**U.S. Department of Energy
100-NR-1 and NR-2 Operable Units
Hanford Site – 100 Area
Benton County, Washington**

Amended Record of Decision, Decision Summary and Responsiveness Summary

September 2010

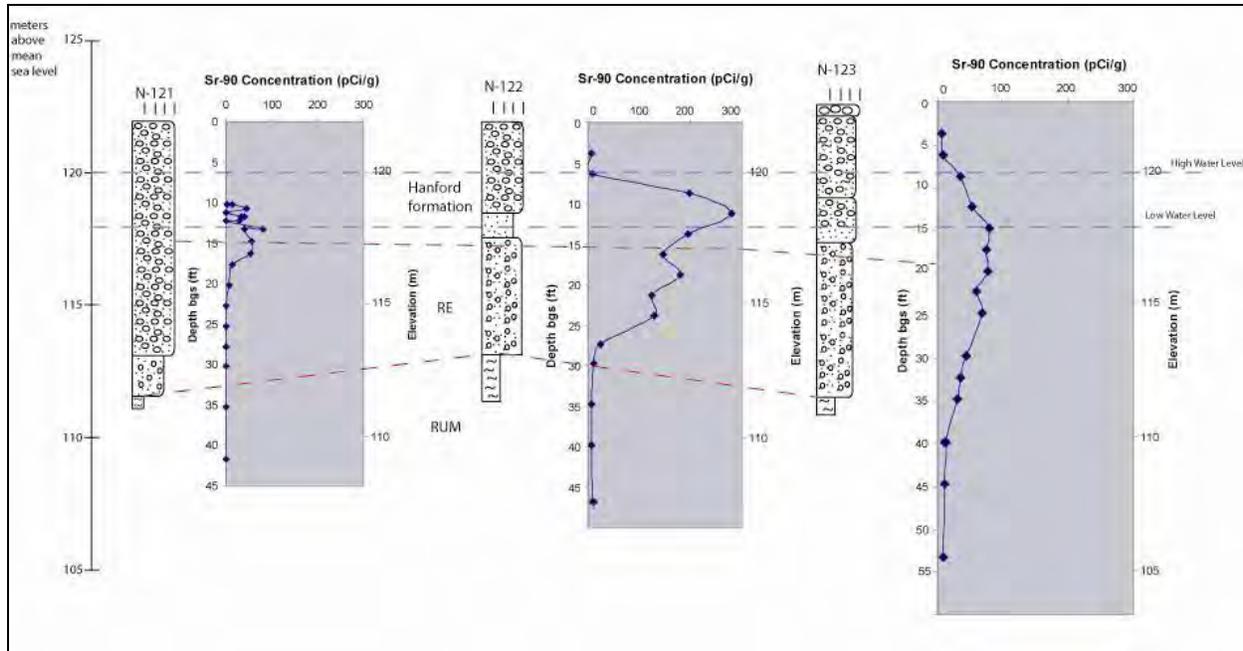
1. General Comment 1 (GC-1): Numerous commenters favored retaining the existing pump-and-treat system to augment the apatite PRB or to serve as a contingent measure in the event the apatite PRB is not successful.

Comment: What caused the existing pump-and-treat system to fail? Reasonable and thorough explanations for this failure have not been given to the public. Is there any way to fix the existing system so that it works?

Response: The inability of the existing pump-and-treat system to reduce Sr-90 flux to the river was not an issue associated with its design or operation; rather it results from the physical/chemical characteristics of Sr-90 that bind it strongly to the aquifer sediments. When the system was operating between 1995 and 2006, at a pumping rate of 60 gallons per minute (gpm), it removed about 0.2 Ci/year of Sr-90, which is about 10 times less than the amount removed from the aquifer by natural radioactive decay (DOE/RL-2004-21, *Calendar Year 2003 Annual Summary Report for the 100-HIR-3, 100-KR-4, and 100-NR-2 Operable Unit (OU) Pump & Treat Operations*). Between 1995 and 2004, a total of 1.6 Curies of Sr-90 were removed from the aquifer. Given that there is approximately 80 Curies of Sr-90 adsorbed to the aquifer sediments in the 100-N Area, approximately 270 years of pump-and-treat operations would be required to decrease Sr-90 concentrations to the 8 pCi/L remedial action goal. Despite the hydraulic containment provided by the pump-and-treat system, and over 10 years of operation, Sr-90 concentrations remained elevated near the shoreline. As a result of this information, pump-and-treat was deemed ineffective for reducing Sr-90 flux to the river and the system was placed in a standby status in March 2006.

Figure B. Sr-90 Concentration Trends at Vertically Nested Monitoring Wells in 100-N Area.

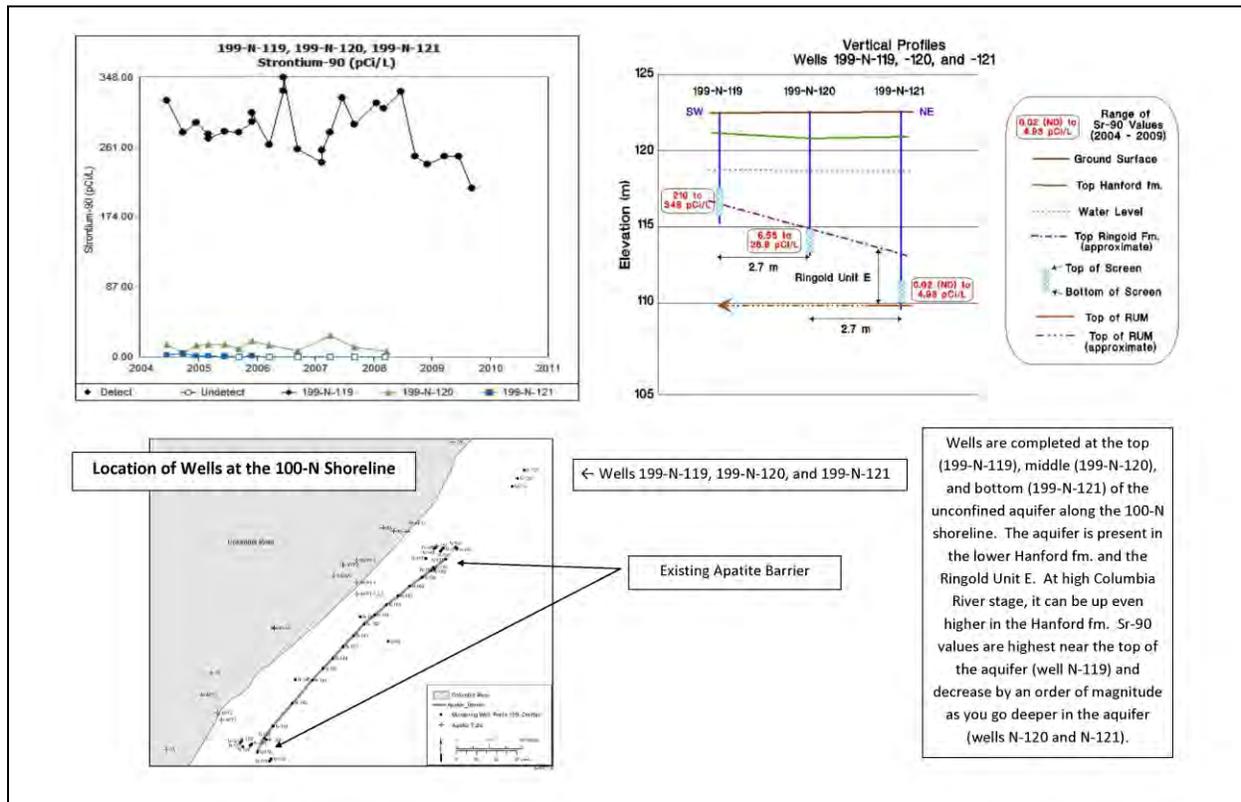
2. GC-2: Several commenters questioned whether the planned depth of the apatite PRB is adequate to address Sr-90 present in the lower portion of the unconfined aquifer (Ringold Formation).

Comment: Why does USDOE plan to only construct the apatite barrier to a depth of approximately 30 feet, when non-USDOE models indicate that the majority of the Strontium-90 is in the lower part of the aquifer?

Response: Recent and historic soil and groundwater characterization consistently show that the highest concentrations of Sr-90 occur in the upper portion of the aquifer (see Figures A and B). To move the Sr-90 plume into the lower portion of the aquifer, there would need to be a significant driving force such as a strong downward vertical hydraulic gradient. Such a condition is unlikely to occur especially with the irrigation restrictions placed on the 100-N Area. Additionally, the Columbia River is a regional groundwater discharge boundary. This means that, the vertical hydraulic gradient is upward to promote groundwater flow from the aquifer to the river. The current apatite PRB design is based on a conceptual site model (CSM) developed from site-specific data. Performance of the barrier will be evaluated in the RI/FS Report, scheduled for completion in December 2011, and in future CERCLA five-year reviews where protectiveness of the decision is evaluated. If it is found that the apatite PRB design is not protective, the design will be re-evaluated.

Figure C. Concentration Trends for Apatite Forming Minerals During and Following Injection (from PNNL-19524).

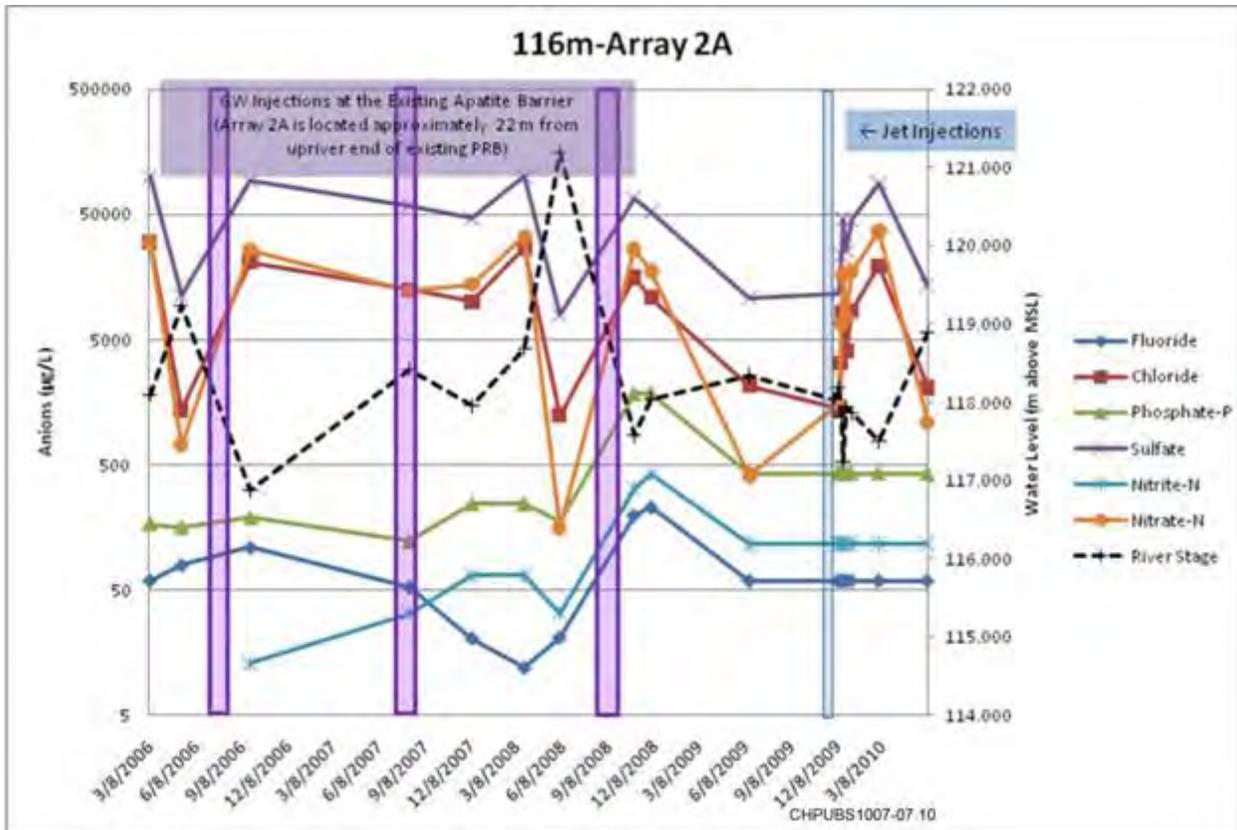
Comment: What chemical impacts will the injection of apatite-forming media have on aquatic and riverbank life?

Response: Based on the bench- and field-scale treatability tests conducted to date, using both low- and high-concentration apatite amendment formulations (PNNL-SA-70033), the most favorable formulation identified for field-scale deployment consists of a solution containing calcium citrate and phosphate. The chemical byproducts from the apatite precipitation process include salts (sodium chloride and calcium chloride) and potentially small amounts of un-reacted sodium phosphate, ammonium nitrate, and calcium citrate.

The citrate will be consumed through aerobic biodegradation processes during the apatite formation reaction; therefore, no residual citrate should reach the aquatic environment. A majority of the calcium will be converted to apatite. While there is some potential for residual calcium to be present following the apatite forming reaction, at the planned concentration the levels of un-reacted calcium that reach the river (if any) are not expected to be toxic to the aquatic species present in this area of the shoreline.

The Tri-Parties recognize that phosphorous is an important nutrient to a number of aquatic species and can result in undesirable affects when present at concentrations in excess of the natural demand. During and following the apatite emplacement process, groundwater monitoring will be performed in the area between the barrier and the river to determine if residual phosphorous is present. If phosphate is present and persists, the measured concentrations will be compared to published guidance values for nutrients in rivers and streams and modifications to the injection process implemented to minimize the amount of un-reacted phosphorous in the aquifer if necessary.
